Colorado Department  
of Public Health  
and Environment

Subject: July 26, 2011 Response Action Work Plan to Extract Additional Groundwater from Upgradient of MW77-WD, Lowry Landfill Superfund Site, received July 26, 2011.

The Colorado Department of Public Health and Environment, Hazardous Materials and Waste Management Division (the Division) reviewed the subject document and developed the following comments. The Division considers these comments preliminary because EPA has indicated they will request a revised work plan.

# G-G' Profile: Hypothesized 1,4-Dioxane Isoconcentration Contours

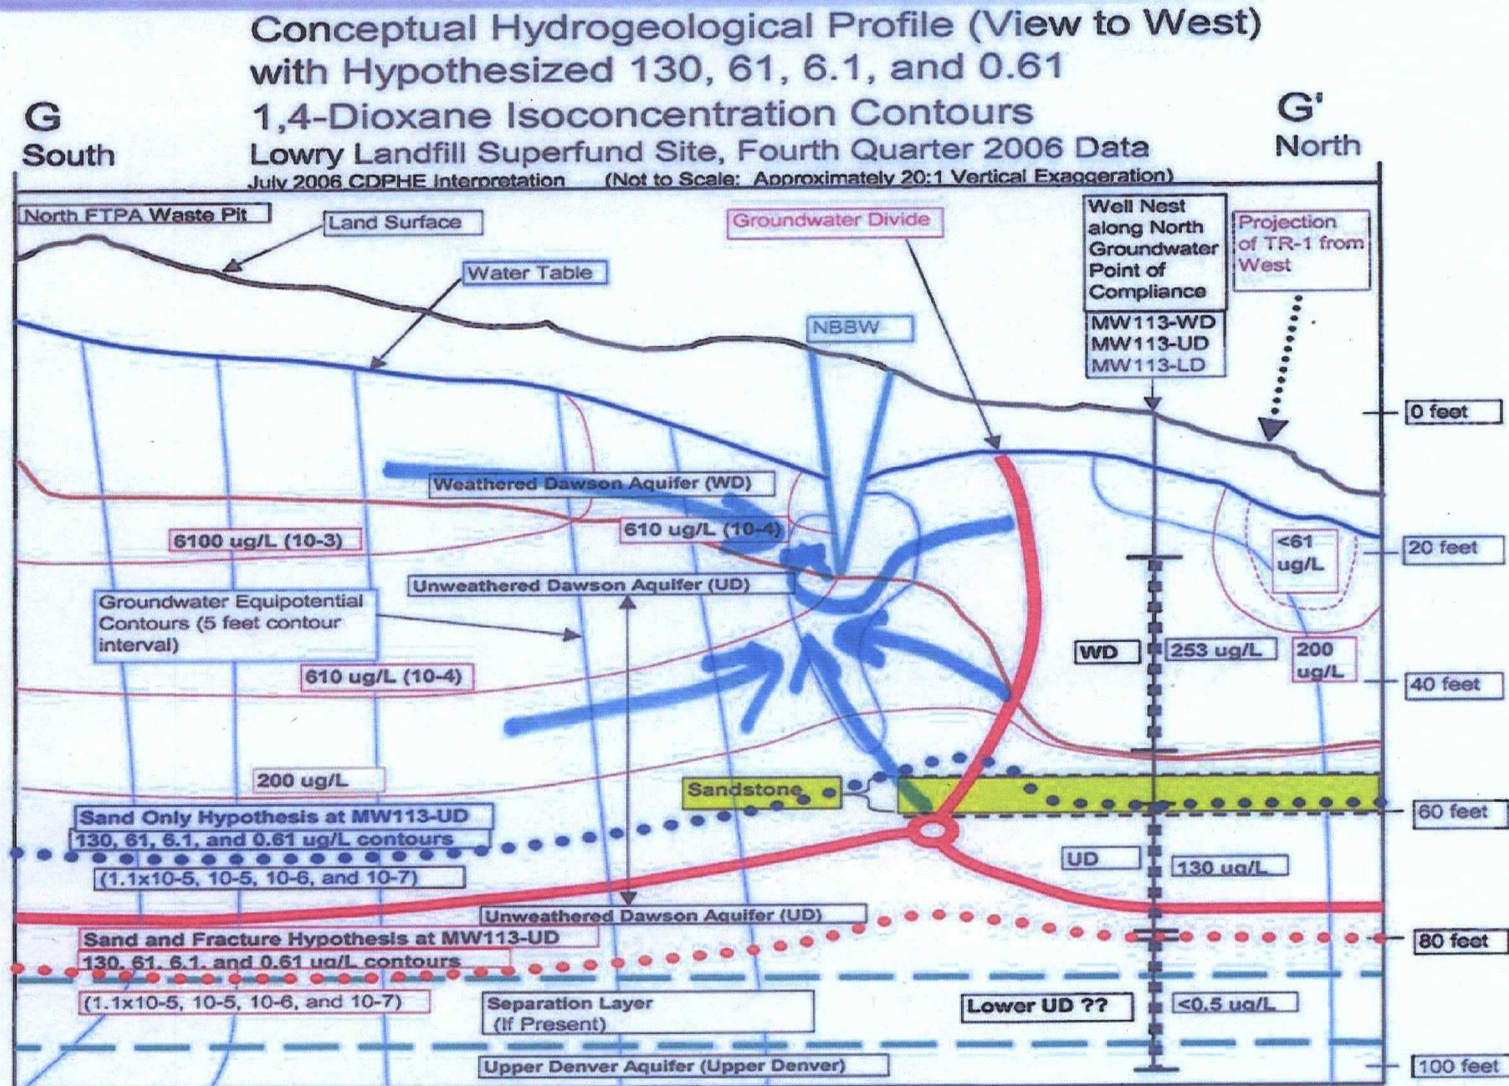
Additionally, as we discussed during our August 16, 2011 meeting with EPA, attempting to maintain a zone of containment on the north side of the NBBW via potable water recharge is inconsistent with the NBBW design (see enclosed NBBW profiles) and may also be contributing unnecessarily to the hydraulic load entering the water treatment plant and Publicly Owned Treatment Works, which are nearing capacity.

FIGURE 4.15  
 NBBW AREA  
 WEATHERED DAWSON  
 POTENTIOMETRIC SURFACE

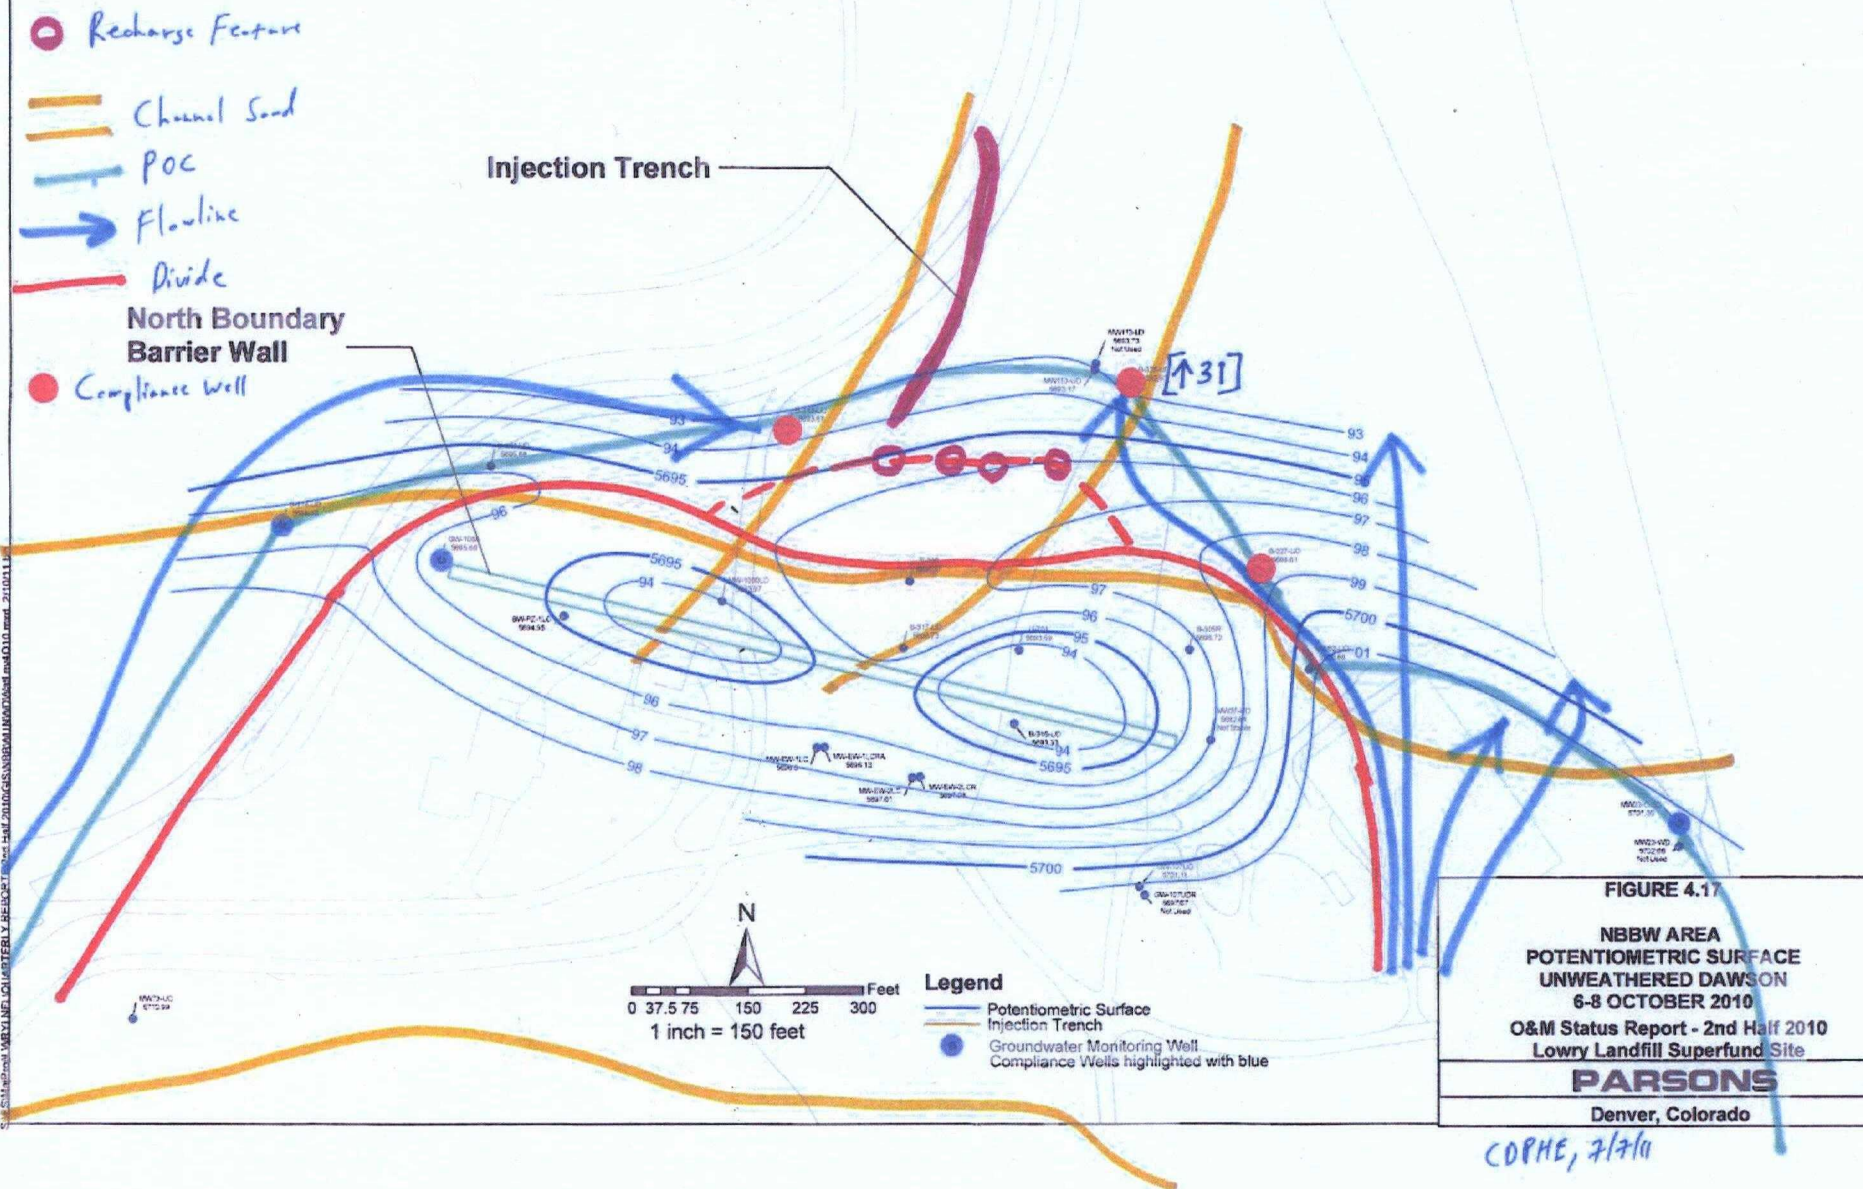
1. Recent (October 2010) WD and UD potentiometric data are consistent with a possible lateral and/or vertical migration pathway from south of the former drum storage pad to compliance wells MW77-WD, MW62-WD, B326-WD, and B326-UD (see enclosed modified Figures 4.15 and 4.17);

have, or are migrating (i.e., residual versus active migration hypotheses, respectively) in the WD to these locations. Additionally, the volatile organic compound 1,1-dichloroethane (1,1-DCA) has migrated to WD well MW77-WD (see enclosed modified Figure 4.15);
